Specific Site Assessment for Coal Combustion Waste Impoundments at Reid Gardner Generating Station

**NV Energy
Moapa, Nevada**

September 2011
Project 092885

Comment 77. Figure 3 Impoundment Water Level Measurements, Notes

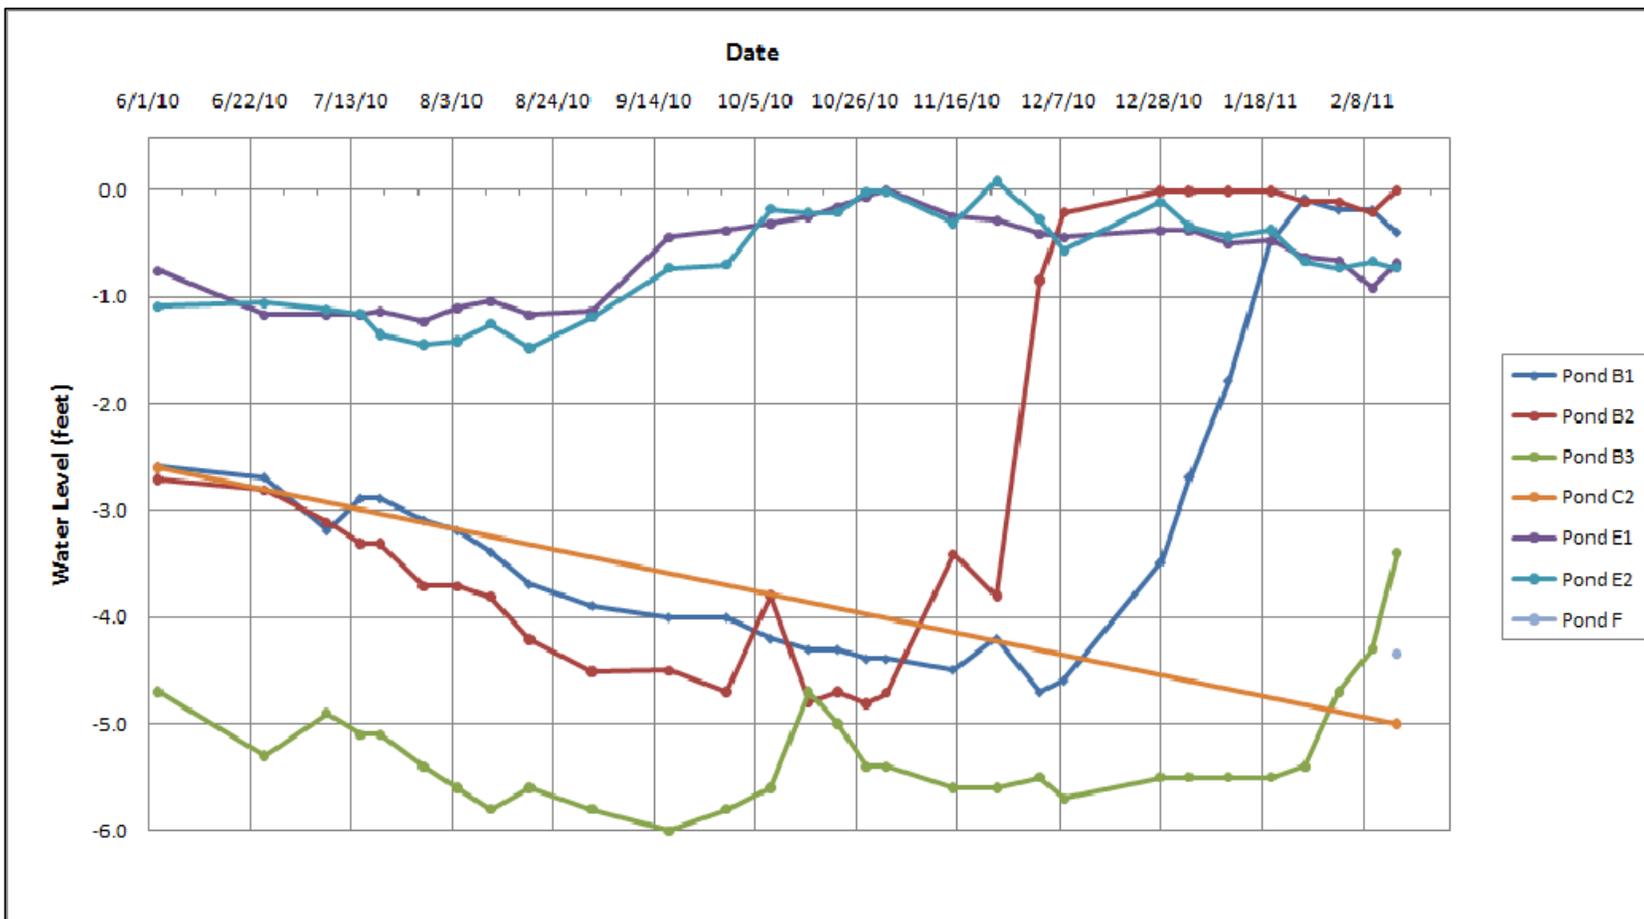
NVE: NVE suggests the following wording change: “3. Water levels for the time frame plotted for Pond C2 were provided for June 3, 2010 and February 15, 2011 only and for Pond F on February 15, 2011 only.”

Comment 78. Appendix B, Photo 25

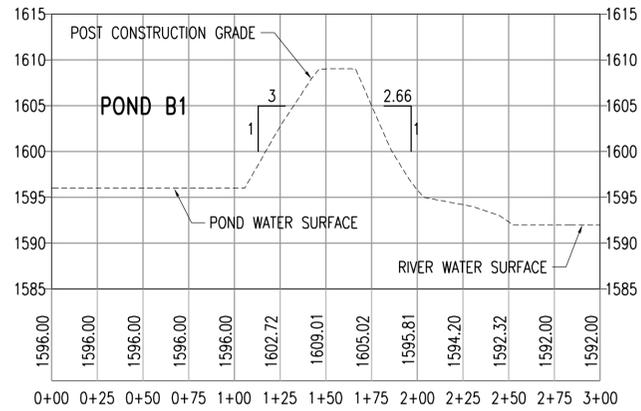
NVE: This photo shows the Muddy River on the left (the caption notes it being on the right).

Reid Gardner Evaporation Ponds Pond B-1 Stability Analysis Section B-C102 Steady State - Effective Stress (Drained) As-Build Condition

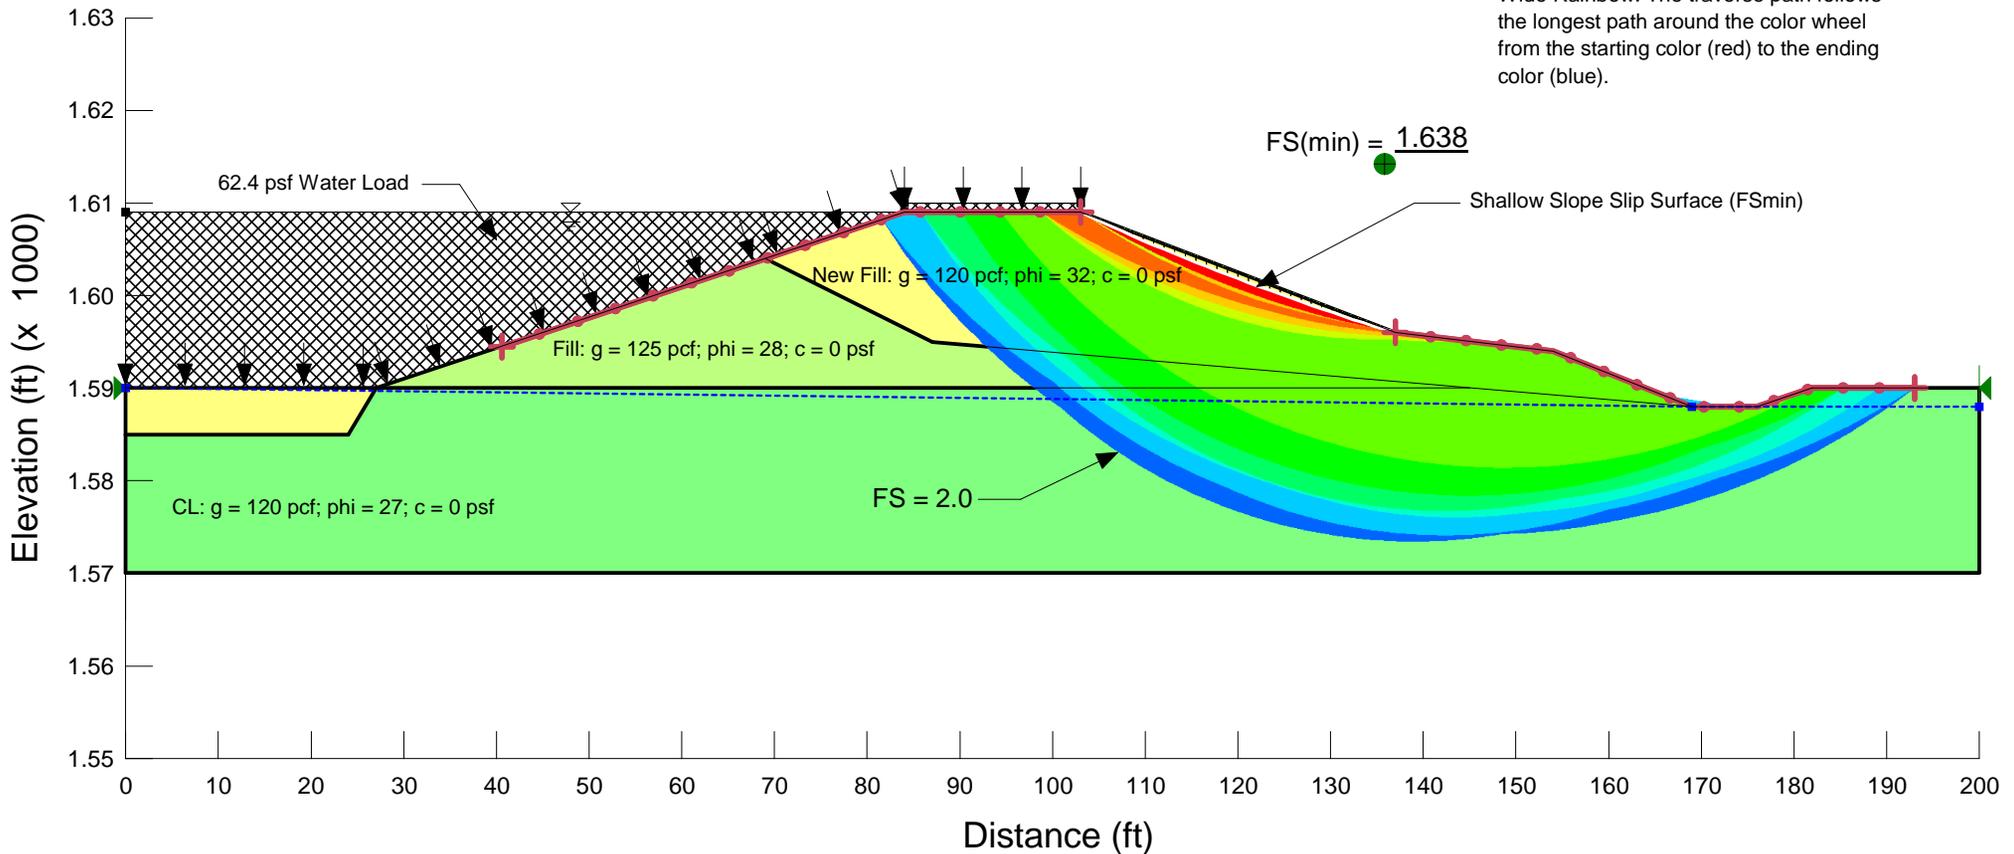
Exterior slope of 2.6H:1V exceeds required minimum FOS of 1.5.
